**Flood Control Project Maintenance  
Levee Inspections**

**Maintenance Issue Types Only, Levee Inspection Report By Mile - Spring 2020**

**Sutter Maintenance Yard Maintenance Area 0017**

Waterway	Bank	Unit Miles	Inspection Start/End	Inspector
Unit No. 01 Lake County Sutter Maintenance Yard - Middle Creek	Left	3.87	03/04/2020 03/04/2020	Luz Dial

Photo 1 of 3 : UCIP\_SP\_2020\_55660\_46886.jpg

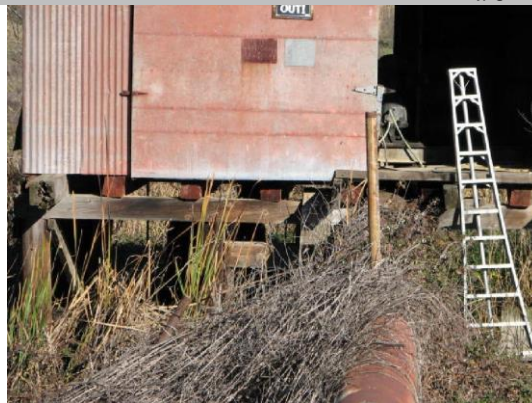
Comment Code						
Inspector Comment						
DS_ID:855 FS_ID:55660 EP_NO: 11467 Repair Type: Non-Urgent Crossing Status: Found UCIP Comments: 10/09/2019 The levee is maintained by DWR Sutter Yard. The State is currently working on purchasing adjacent land to eventually pursue the de-activation of this levee. Levee crown width is about 12 feet. The UCIP inspection was completed with DWR Inspector, L. Dial, and DWR Sutter Yard Supervisor, B. Reniff. Crossing remains Non-Urgent; crossing has been abandoned. Owner will need coordinate with the CVFPB to remove or abandon crossing according to Title 23 requirements. (O. Magana - DWR UCIP)10/19/2016 Crossing appears to be in good condition. (DWR Sutter Yard-AFreitag)06/14/2016 Crossing appears to be in good condition.04/23/2015 No issues seen with pipe.07/03/2014 Same as last inspection.08/02/2013 Same as last inspection.12/23/2013 Same as last inspection. FIELD_STRUCT_DESC: 2 of 2: 24-inch steel drainage pipe through the levee, 8 feet below the crown. Drainage pumping plant on the landside (LS). Flap gate on the waterside (WS) end. (one 16-inch and one 24-inch pipes [HLM 7.79] authorized under Automatic Board Order (ABO) issued as Permit No. 11467, 1975 - Modglin). [Additional Reference(s): DWR Levee Log, 2005. USACE Sacramento O&M Manual 506.3, August 1961, (HLM 7.19)]. FS Date: 10/9/2019 3:12:00 PM

24-inch steel pipe and pump house on LS.
